BROCKMAN RESOURCES LIMITED

MARILLANA IRON ORE PROJECT

**SUPPLEMENT TO RESPONSE TO PUBLIC
SUBMISSIONS**

EPA ASSESSMENT NO. 1781

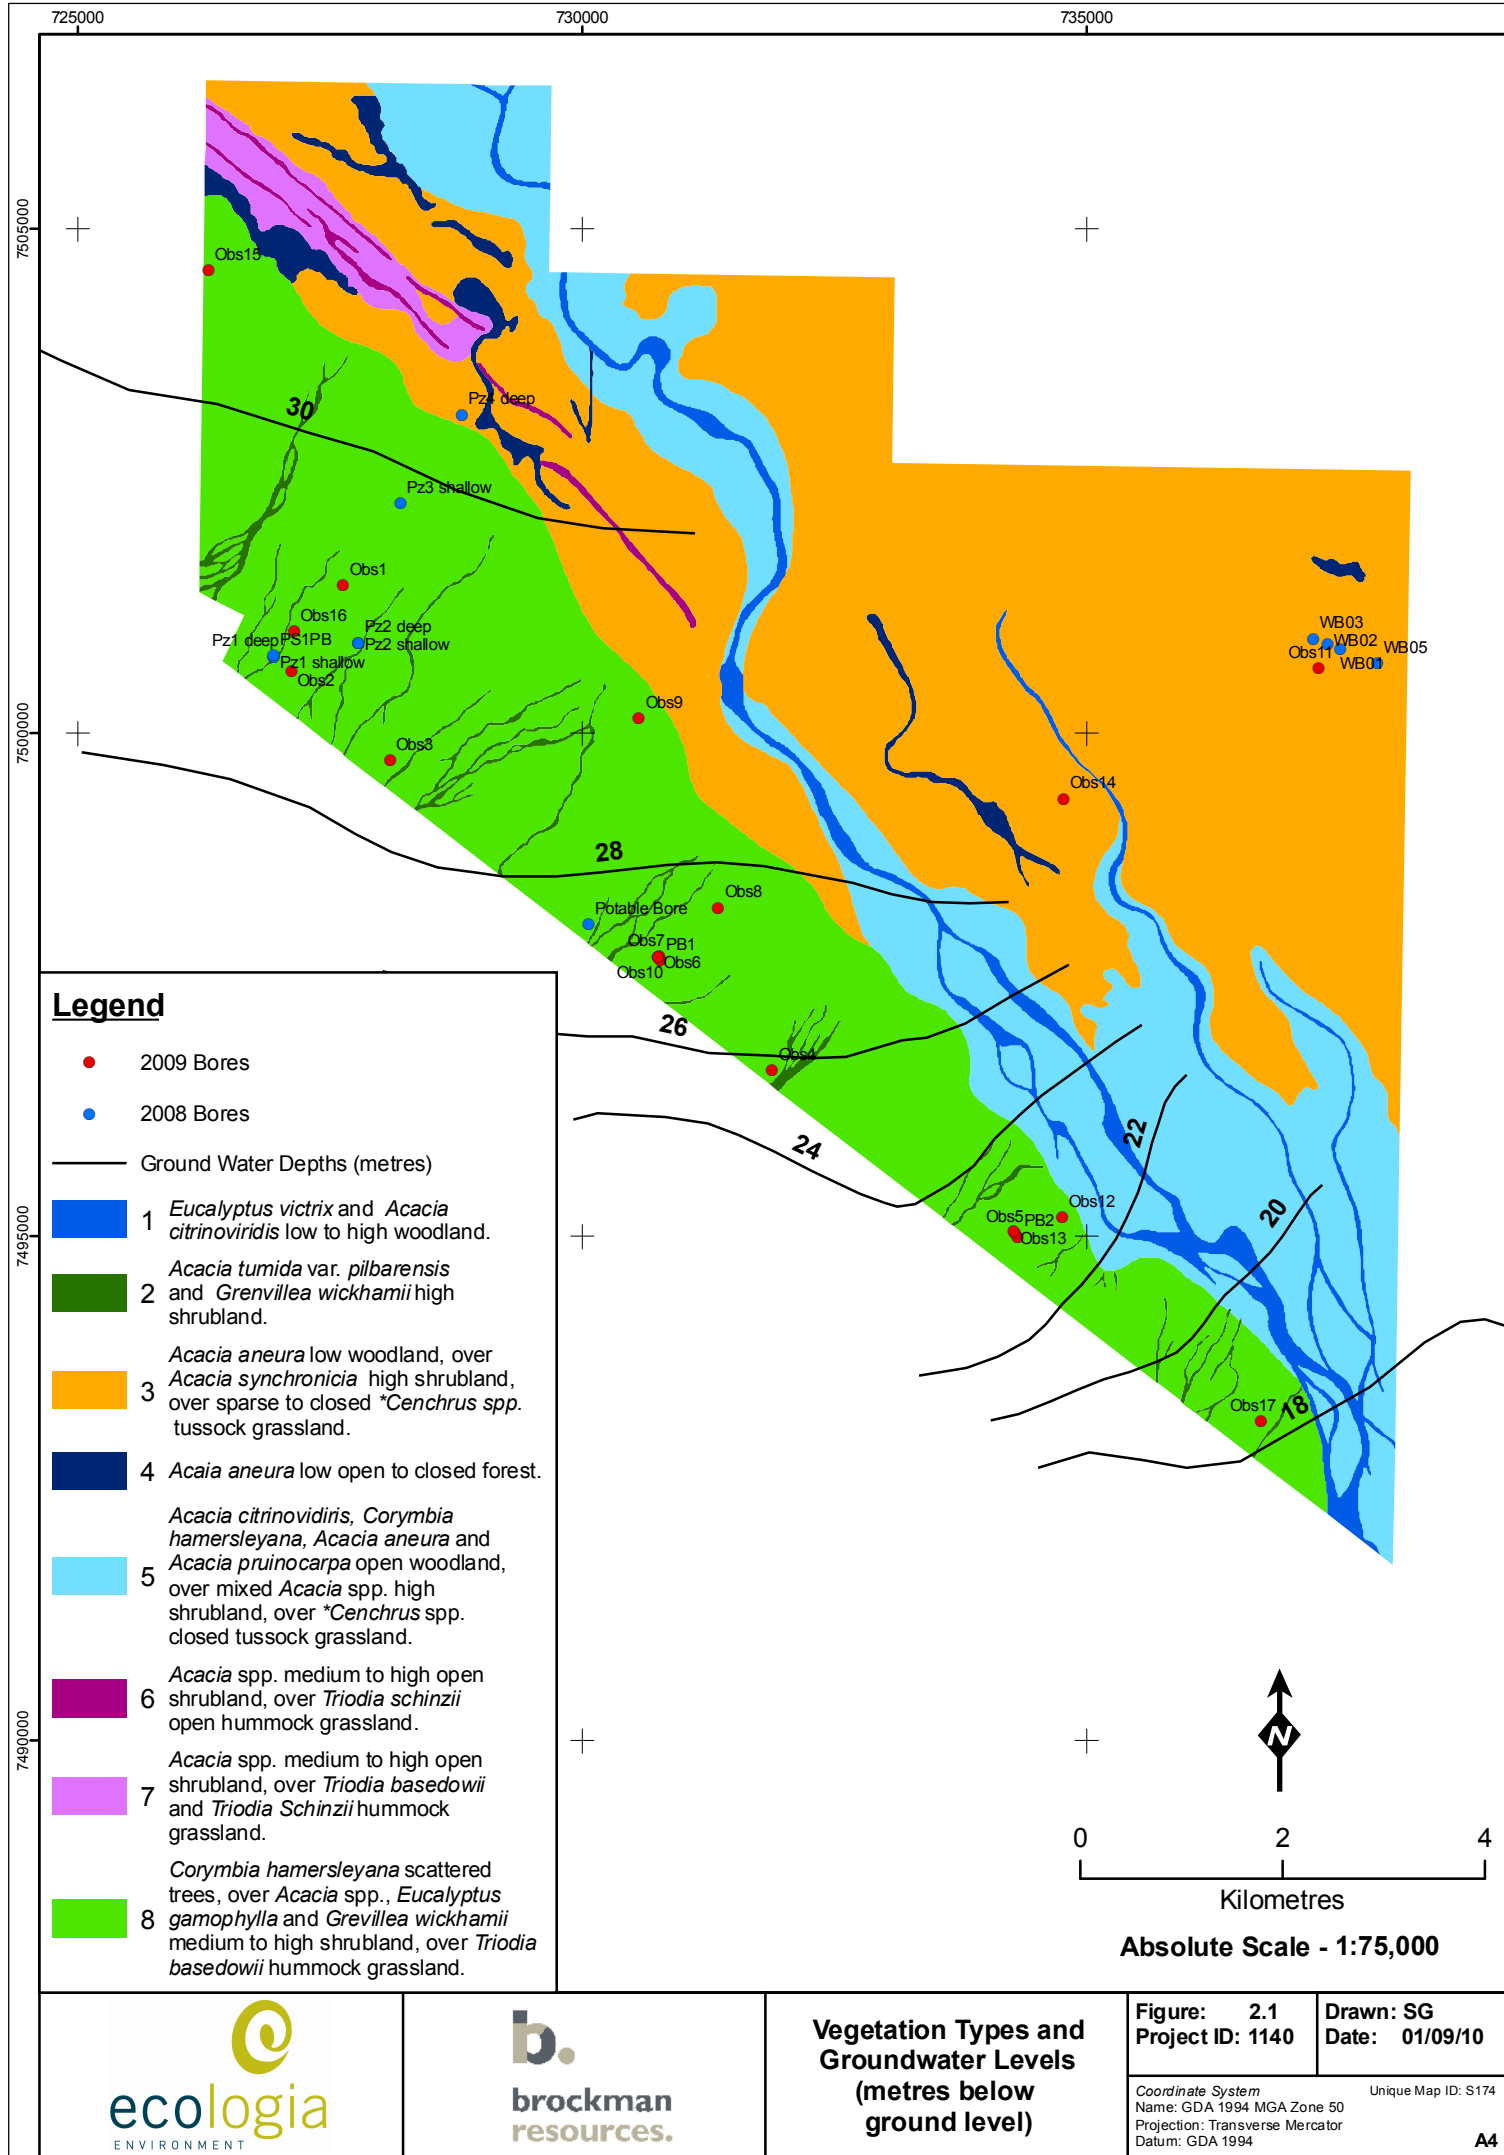
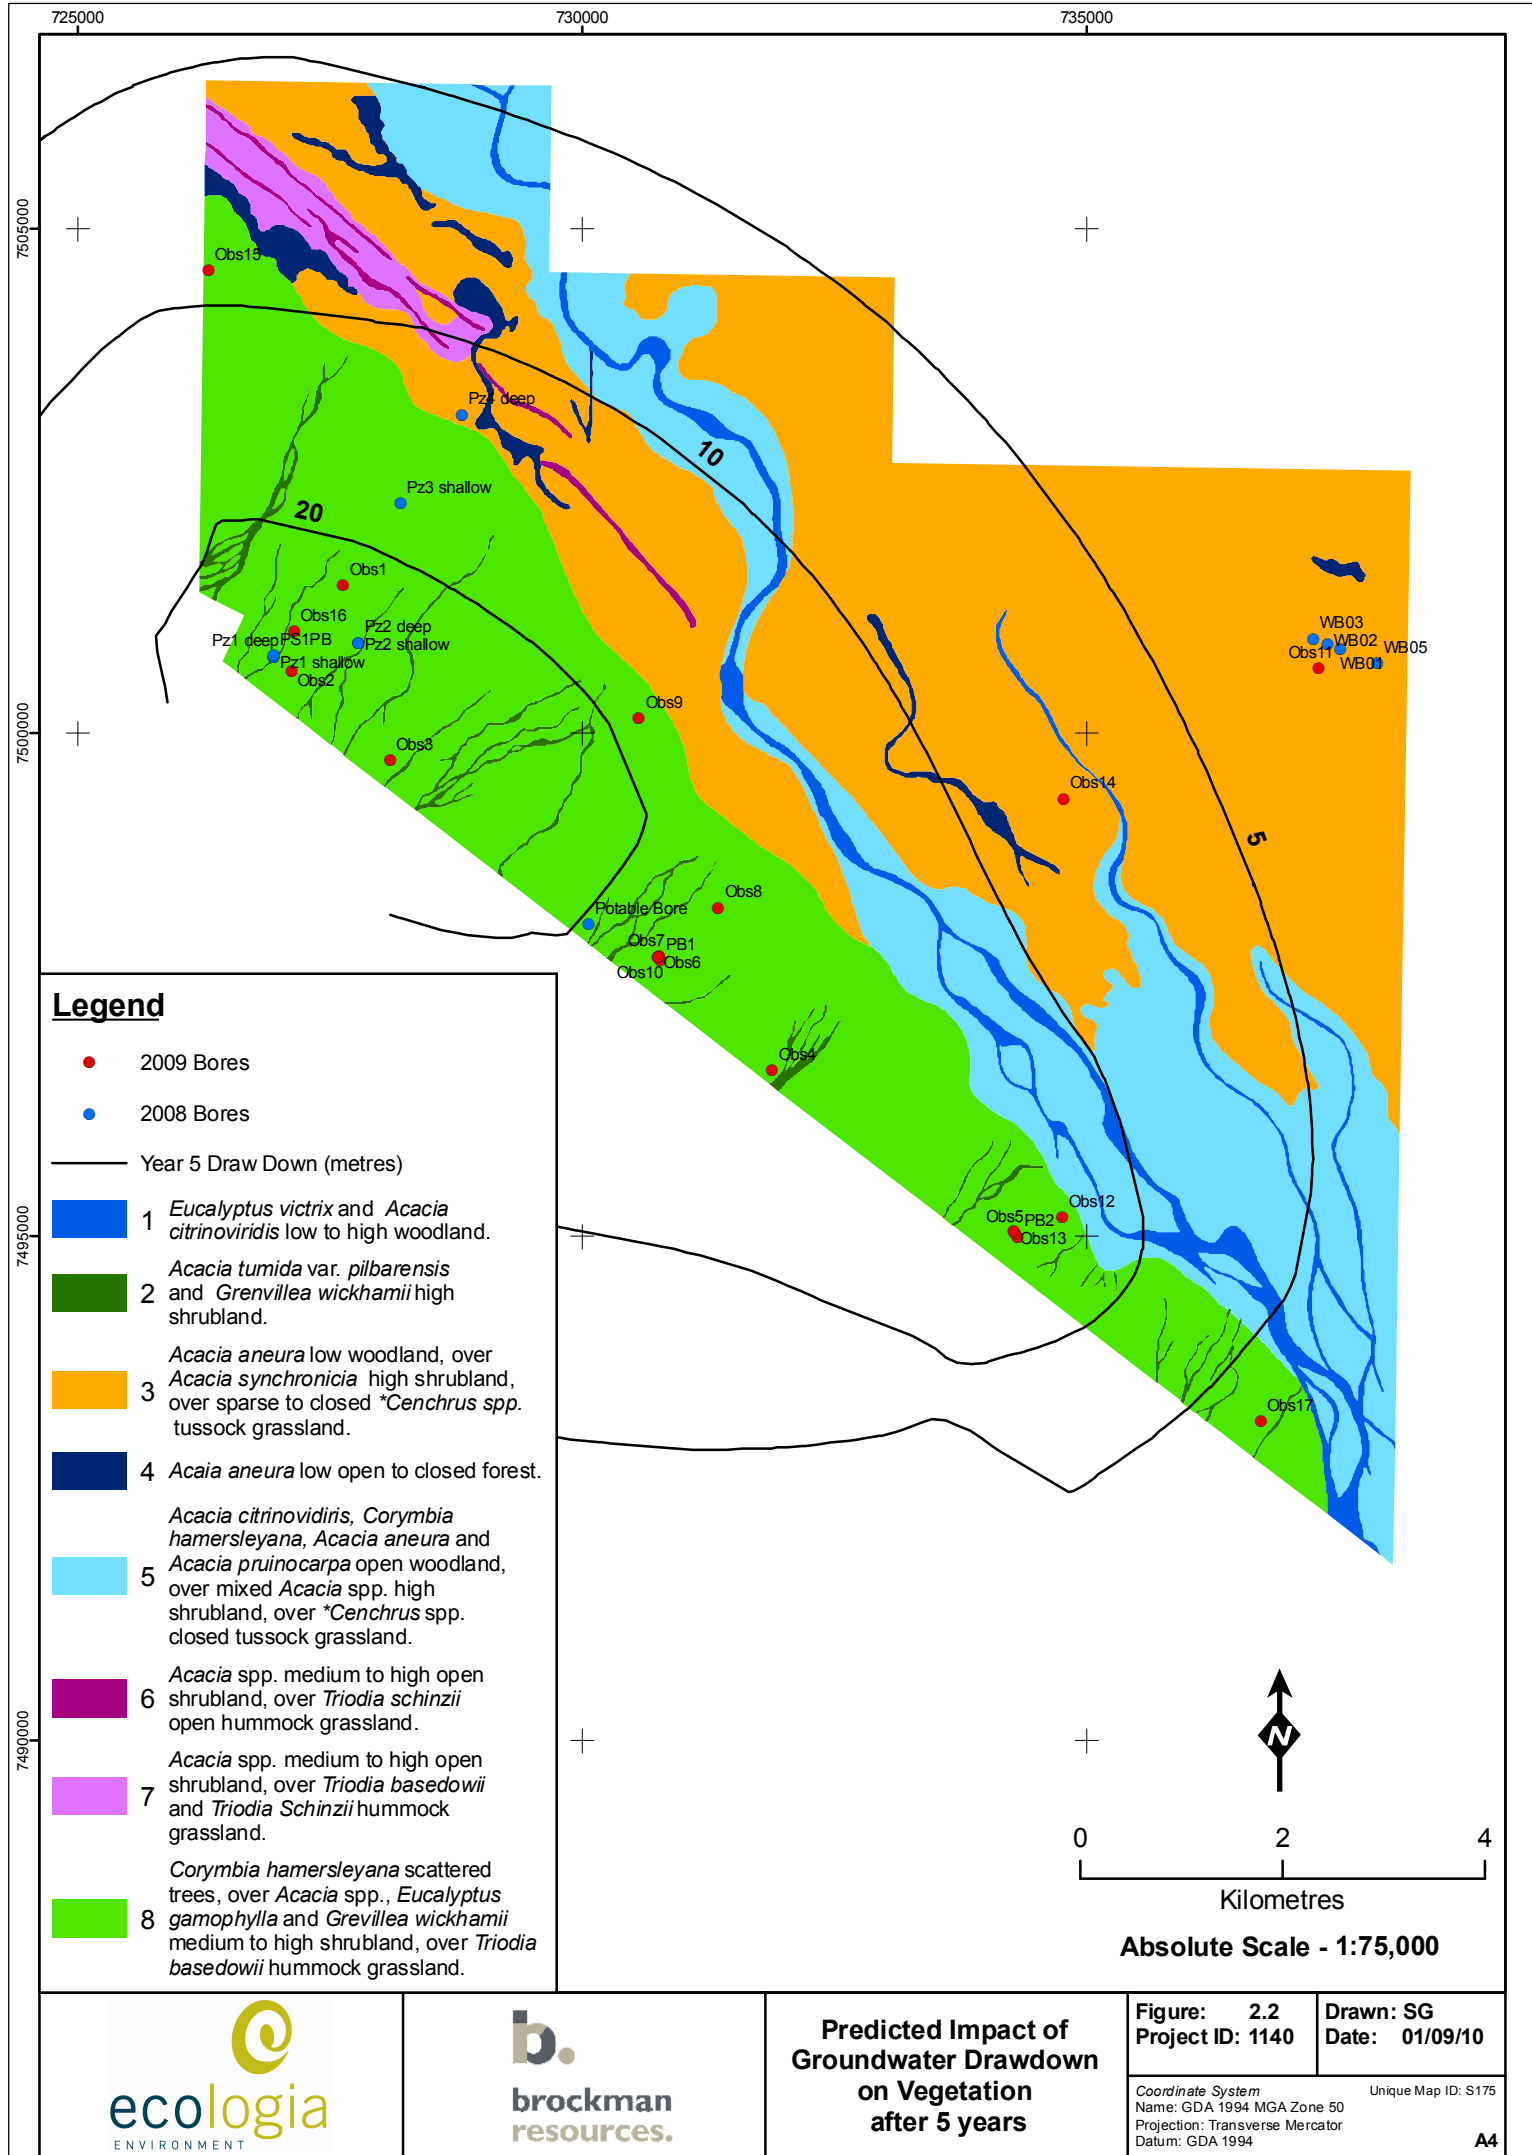
Please provide further details regarding management and monitoring actions proposed in relation to groundwater dependant vegetation. This should include:

- Clear spatial identification of any GDE which could potentially be impacted by the proposal;
- An outline of the proposed monitoring programme for GDE's including methodology and schedule;
- Criteria and trigger values to be assessed by the monitoring program; and
- Contingency actions to be taken in the event that trigger levels are exceeded.

Groundwater levels in relation to vegetation types across the Marillana site are shown in Figure 2.1. As identified in Section 6.7 of the PER, two sub-units containing one potentially phreatophytic species, *Eucalyptus victrix*, were recorded within the survey area

The predicted impact of groundwater drawdown on vegetation over the 20 year mine life is shown in Figures 2.2 – 2.5. The drawdown is at a maximum of 40 m below pre mining levels in the western end of the orebody to facilitate dry mining conditions and reduces with distance from the main pit area. Whether the extent of the drawdown proposed is likely to significantly affect the potentially phreatophytic vegetation lining the Weeli Wolli Creek is yet unknown, given the predicted natural variability in groundwater underneath the creek.

At the end of the 20 year mining period, the 20 m drawdown extends 8 km across the Weeli Wolli Creek. The 10 m drawdown extends across the remainder of the Weeli Wolli creek to just beyond the tenement boundary. The current water table in within the drawdown zone varies between 18 to 30 m. Brockman has a drilling program underway on the Marillana tenement to investigate the interaction between surface water flows and groundwater near Weeli Wolli Creek. This will provide further information to be fed into the Phreatophytic Vegetation Monitoring Plan and results (see Section 2.1.2 below).
